LEXINGTON-FAYETTE URBAN COUNTY GOVERNMENT CONTRACT CHANGE ORDER Page 1 of 2		Date	September 16, 2016
		Project	Fire Station #2 Replacement
		Location	Lexington
To (Contractor) Olympic Construction, LLC 216 Bromme Drive Nicholasville, KY 40356		Contract No.	013-2016
		Original Contract Amt	\$4,618,900.00
		Cumulative Amount of Previous Change Orders	-\$1,379.24
		Percent Change - Previous Change Orders	-0.03%
		Total Contract Amount Prior to this Change Order	\$4,617,520.76
		Change Order No.	4
		You are hereby requested to comply with the following changes from the contract plans and specification:	
Current Change Order

PROJECT: Fire Station #2 Replacement

CHANGE ORDER NO. 4

Work Changes Proposal Request No. 6

Lexington
 Replicemetal Inc.
 VENDOR NO. 13117
 Reflected Ceiling Plan A-103
 16-2015

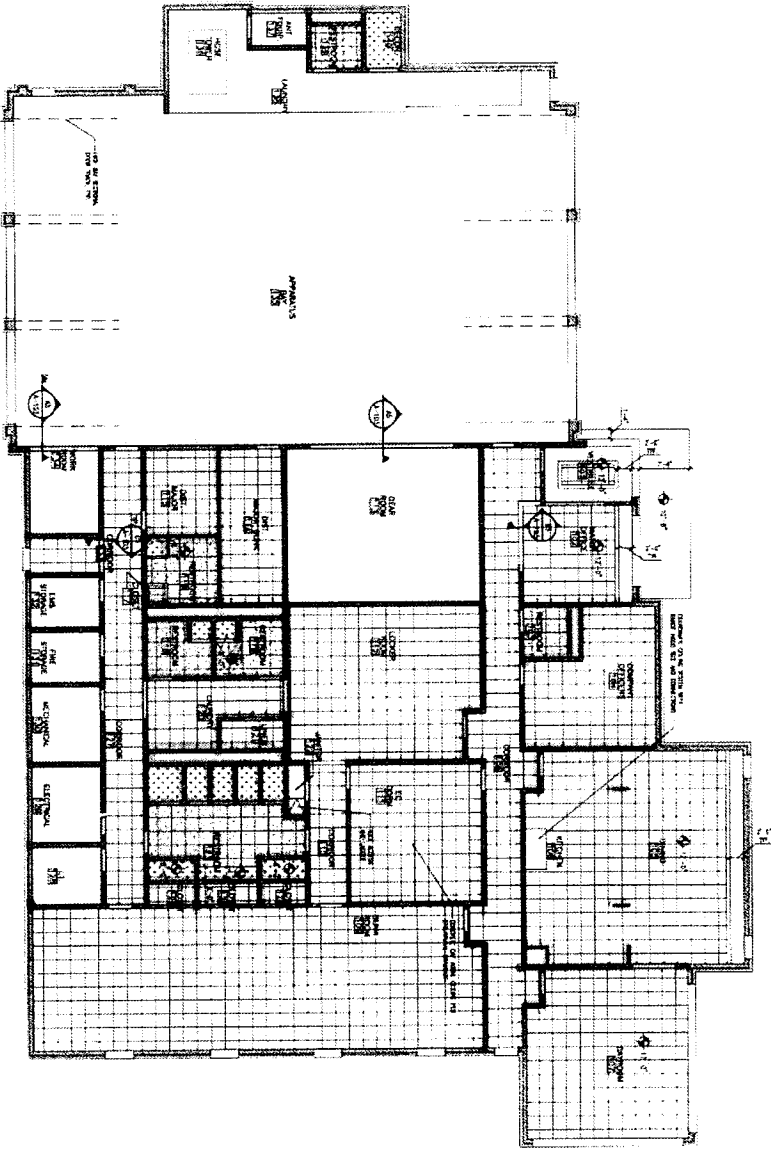
1. Per contractor request, see walls that are to be tight to deck above in the attached document. All other walls are to extend above ceiling by at least 1 CMU course or 12" for metal studs with bracing/kickers at 24" o.c. attached to deck above. Drywall should extend above ceiling a minimum of 6" or as shown in the documents.

Full Height (Load Bearing, Rated, Separation)
 Reduce to just above ceiling (Non-Load Bearing)

Station No. 13117
 C-102
 161-2015
 13117

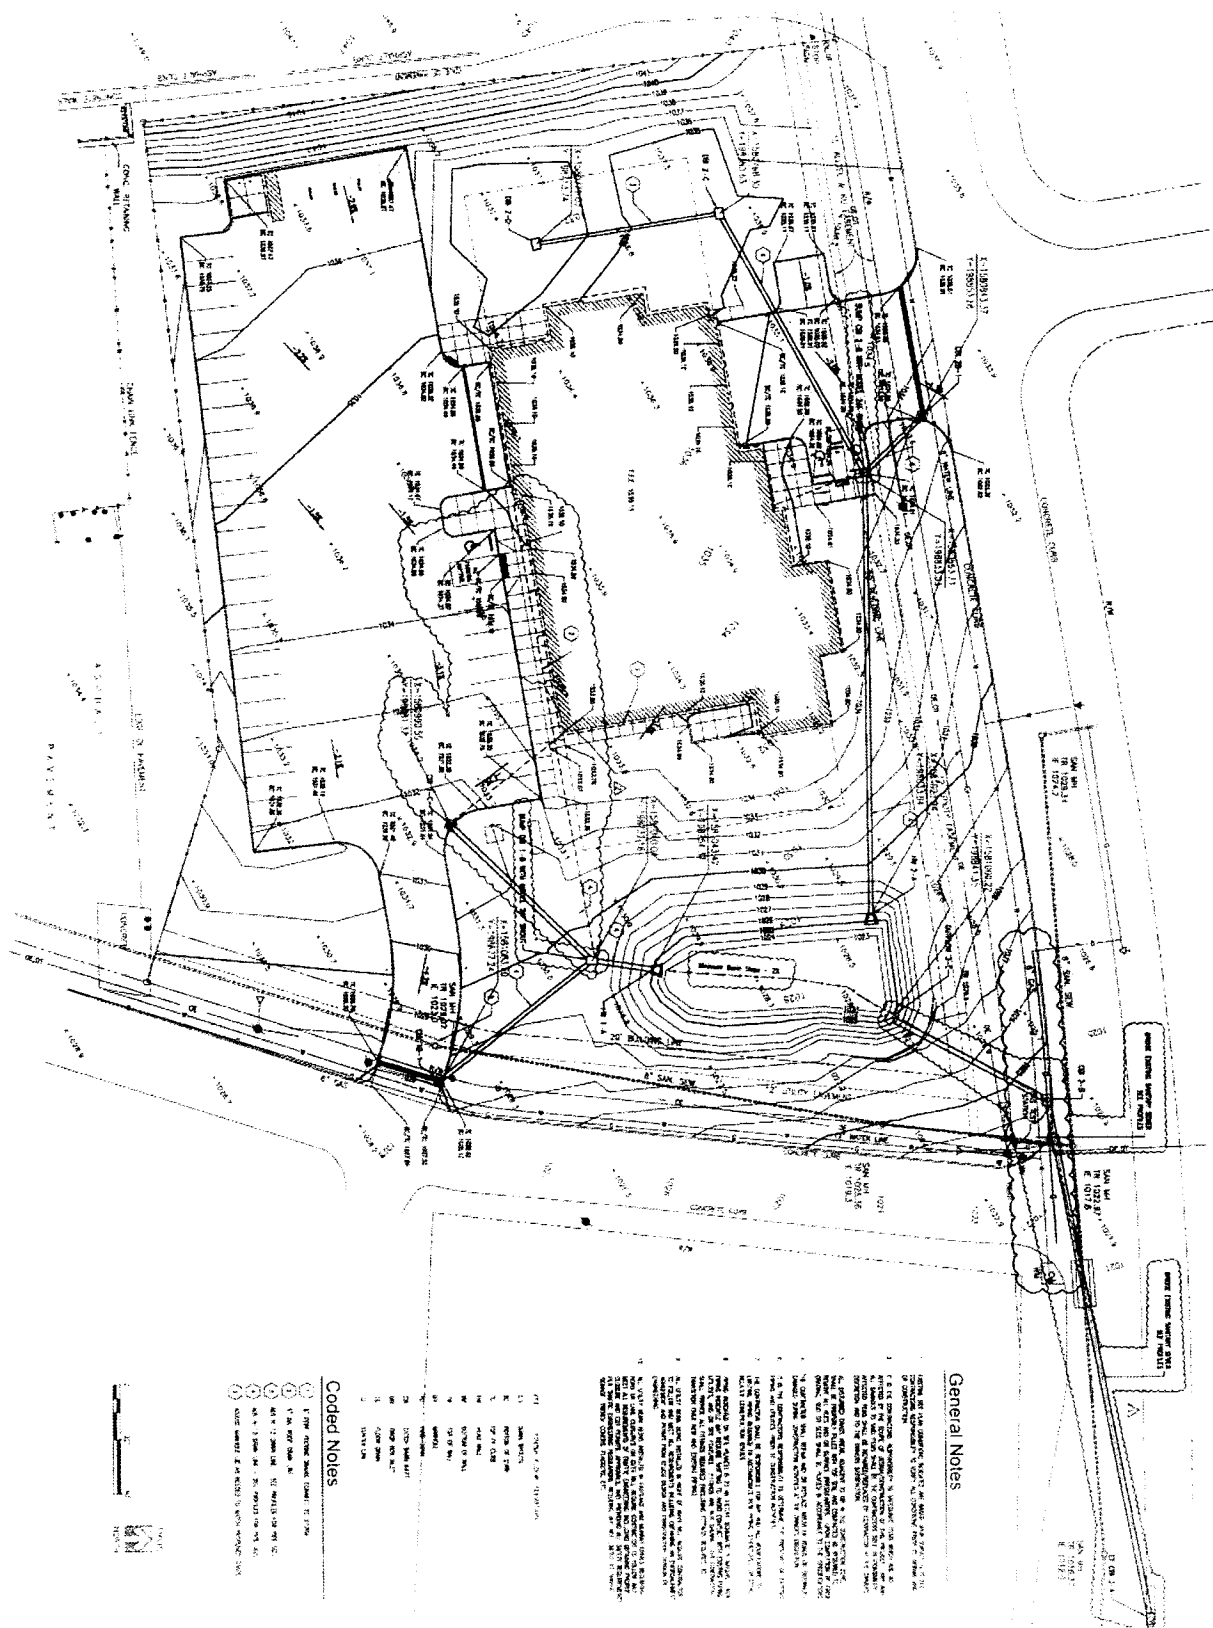
2. Per unforeseen existing utility locations, where the depth is not sufficient. There is not the required storm depth available. There is only 14" between the gas and water line and since the soil strata below the water line is rock and the existing sewer main will interfere with the storm routing, see the modification of the storm sewer as shown in the attached. The gas line has been discussed with Columbia Gas and they are in process of a relocation design for their gas line that is in conflict. The storm and gas line relocation will need to be coordinated once the design for the gas is complete and available.
